ADDENDUM NO. 1

Date: **February 27, 2023**
Issued by: **Sacramento City Unified School District**
Project: **Project #0363-409 Theodore Judah ES Paving Repairs**

KEY PLAN	
➔	
SHEET TITLE: GRADING PLAN	
JOB NUMBER:	SHEET NUMBER:
DATE: NOV 8, 2022	ADD1 C2.1
REVISION:

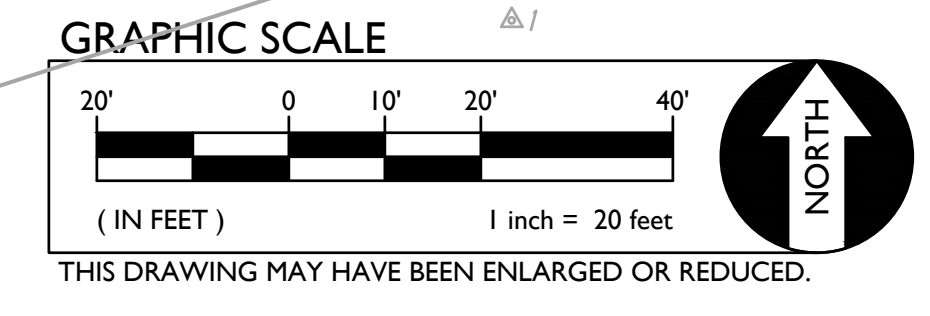
- AD01.10 Sheet C2.1 – Grading Plan: **Replace with the attached ADD1 C2.1.** Additional flatwork, seat wall and top of curb grades have been added to clarify the area northwest of stage area. Added additional grading limits.

JOB NUMBER: SHEET NUMBER:
DATE: NOV 8, 2022
REVISION: **ADD1 C2.2**

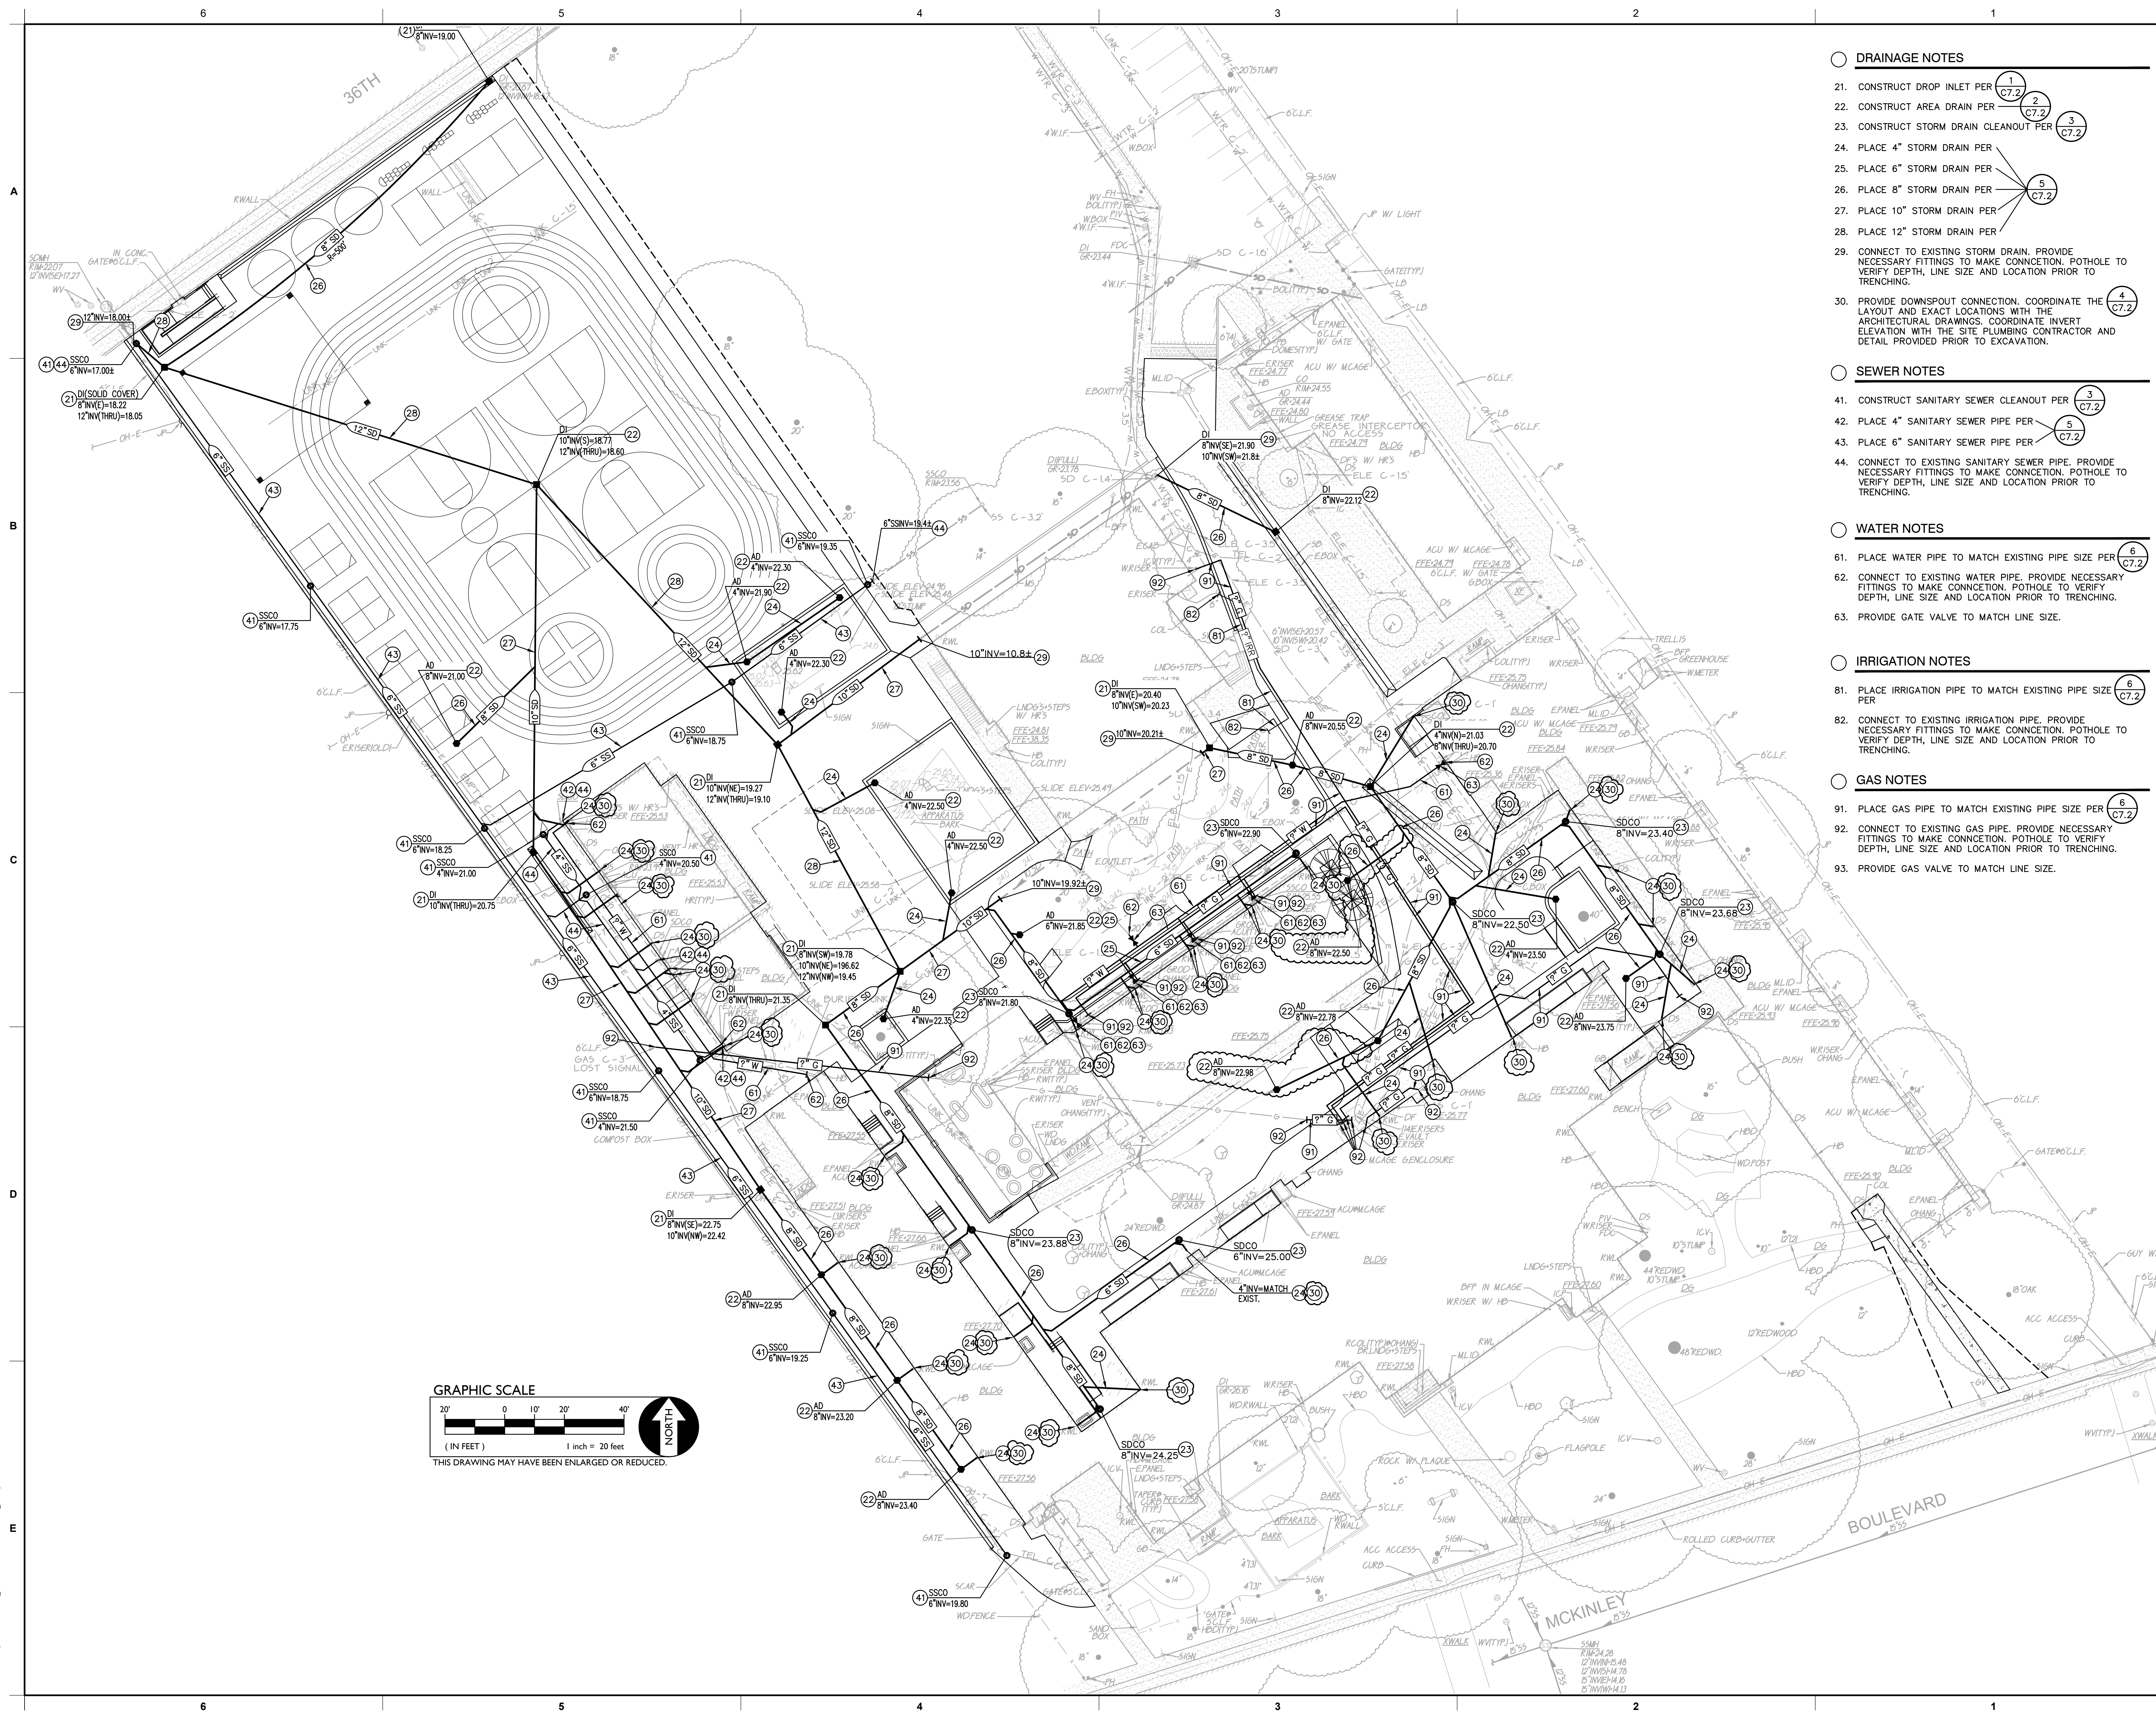
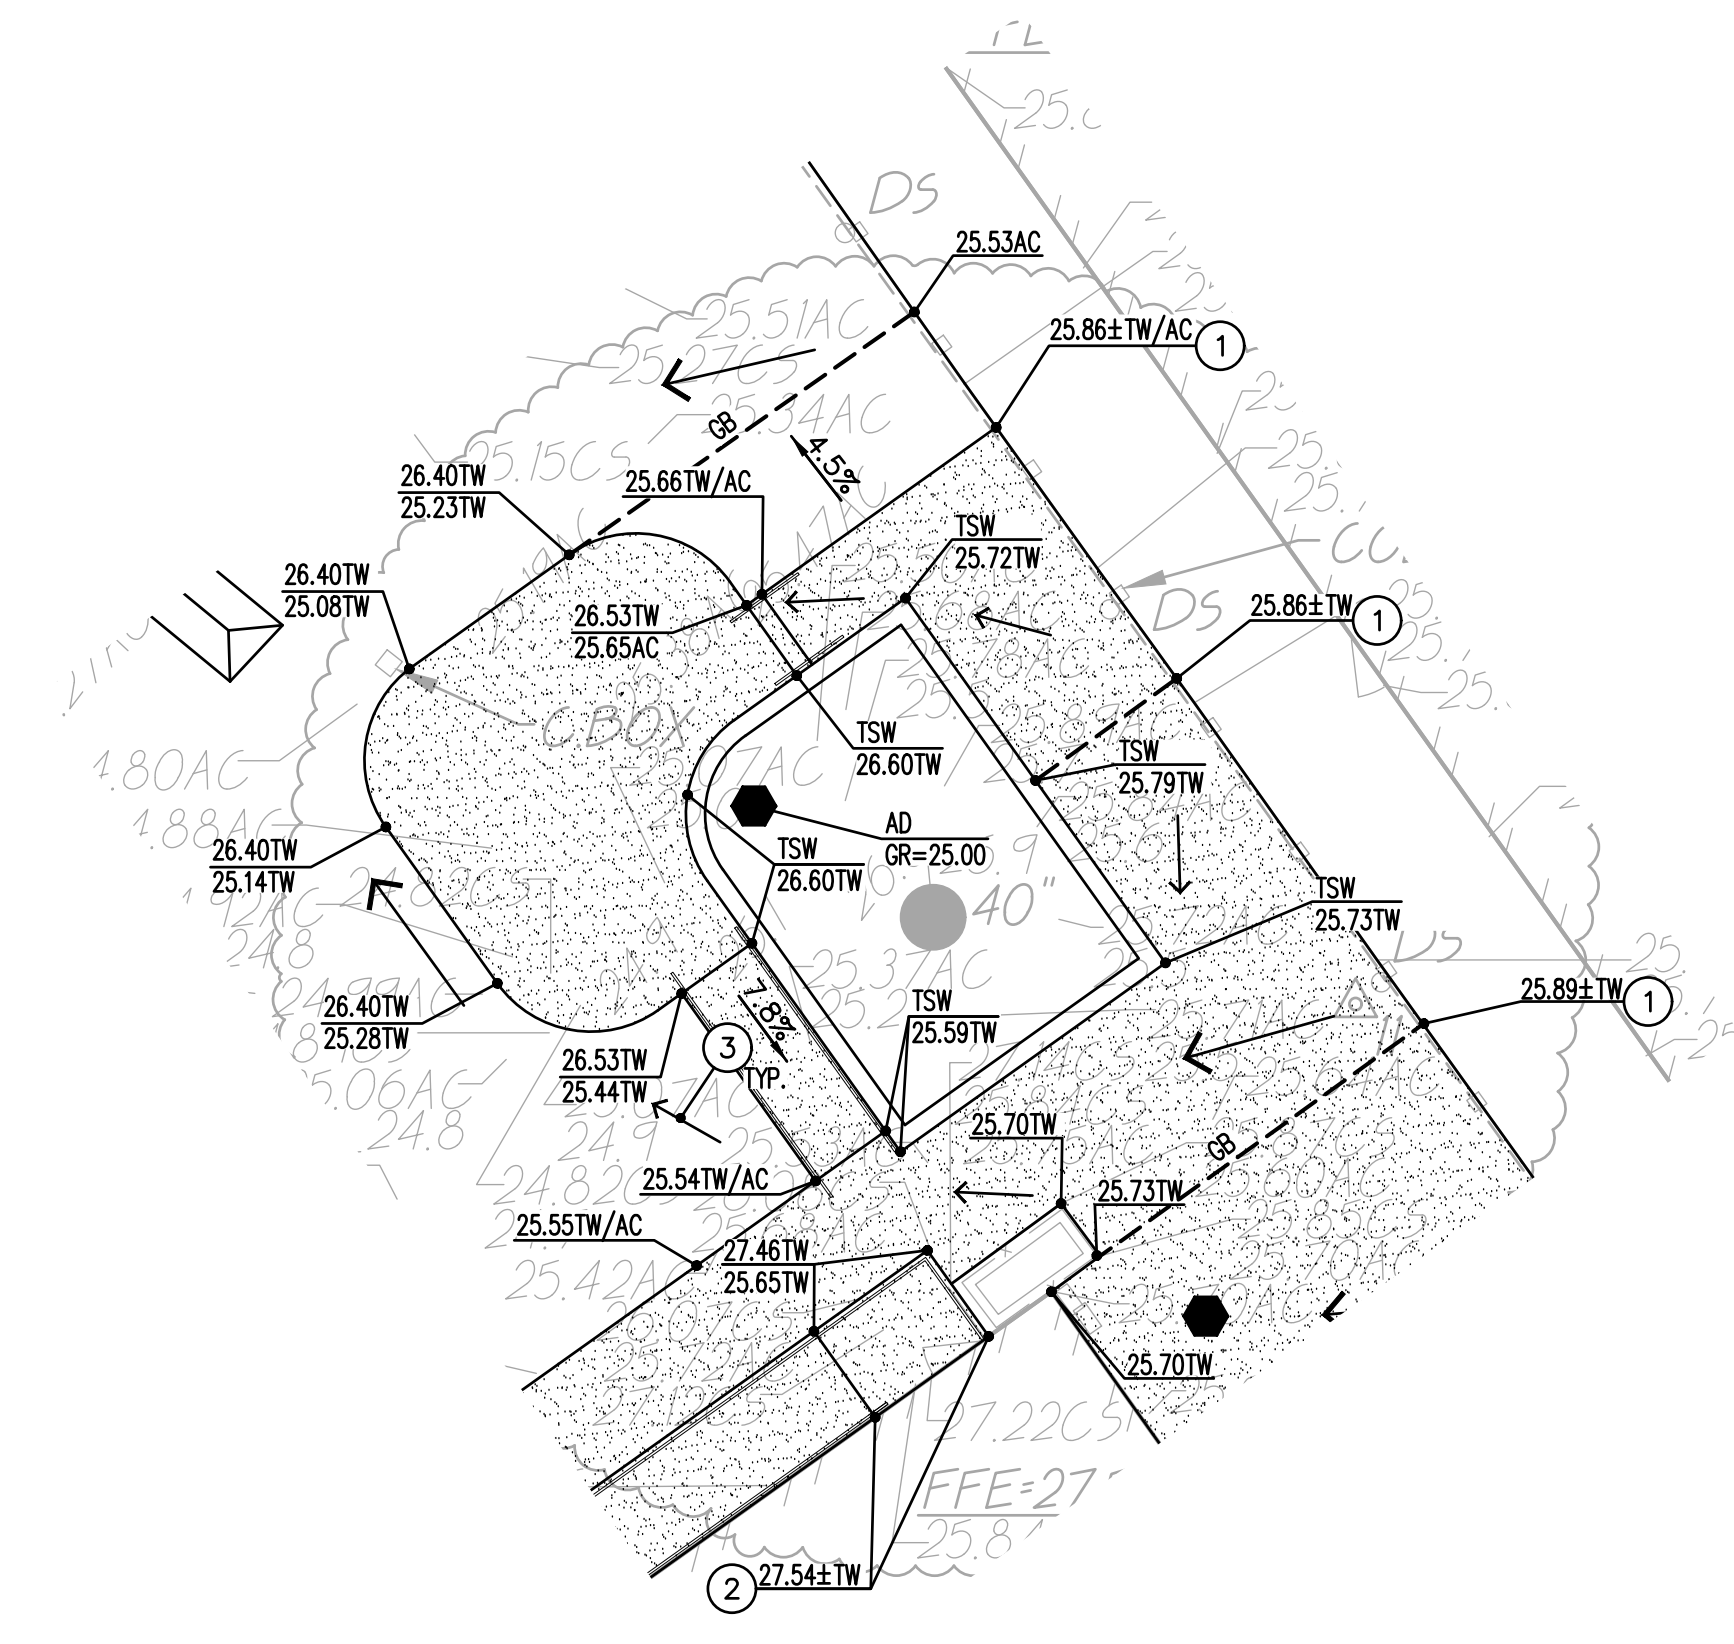
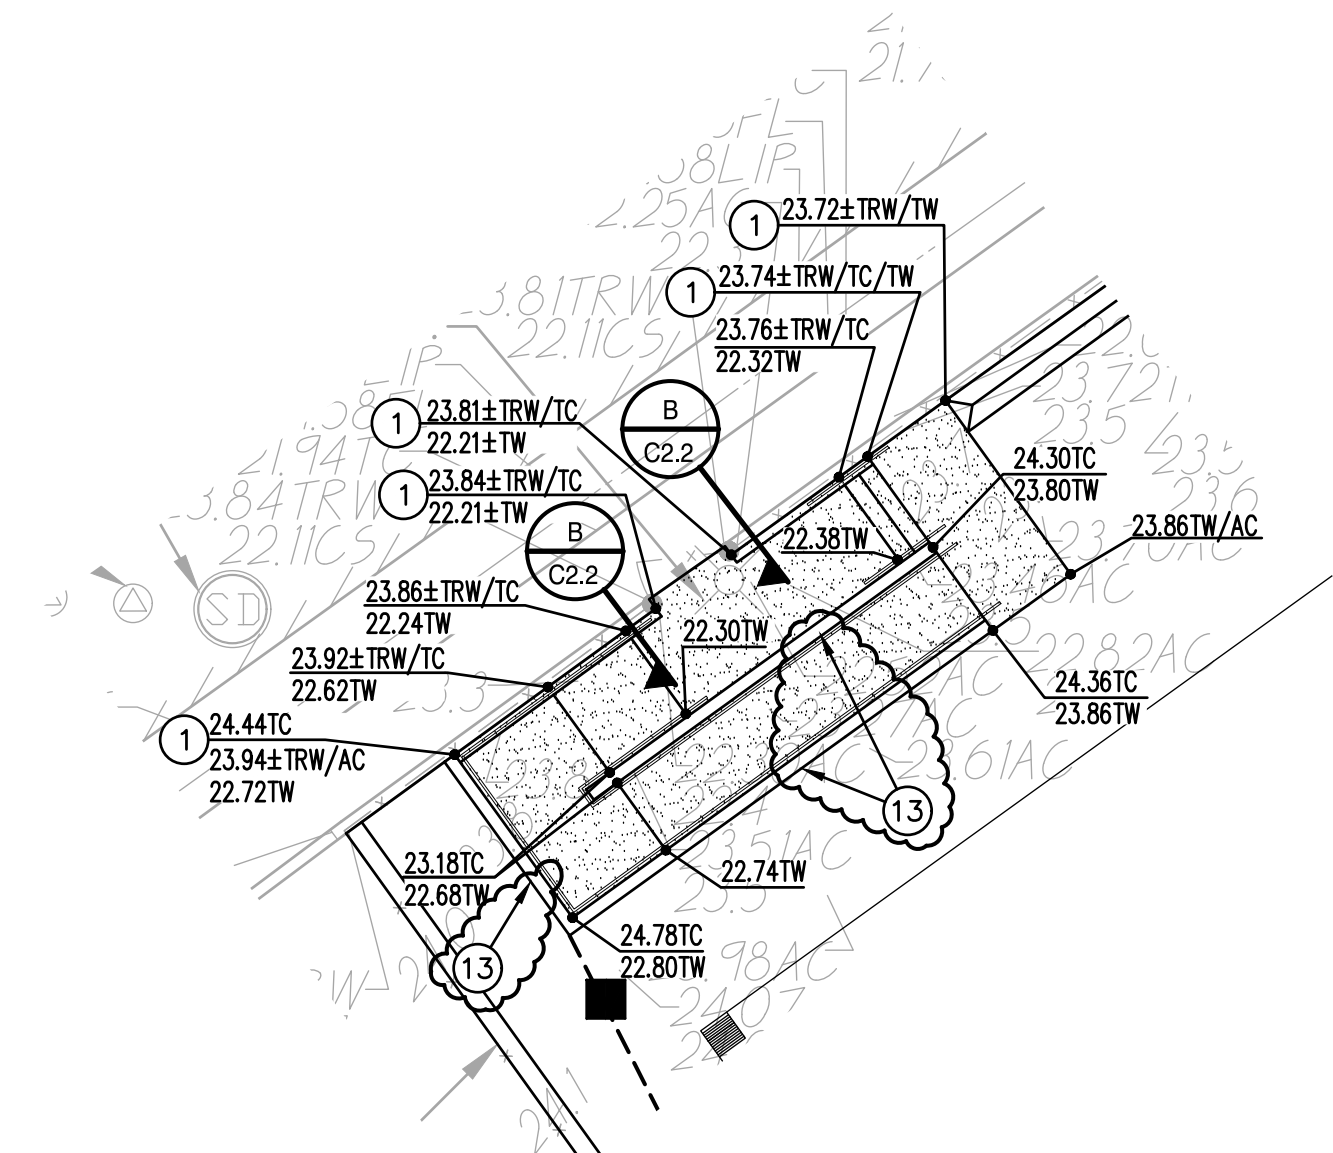
- AD01.11 Sheet C2.2 – Enlarged Grading Plan: **Replace with the attached ADD1 C2.2.** Note to use variable curb detail at the access ramp from 36th Way.
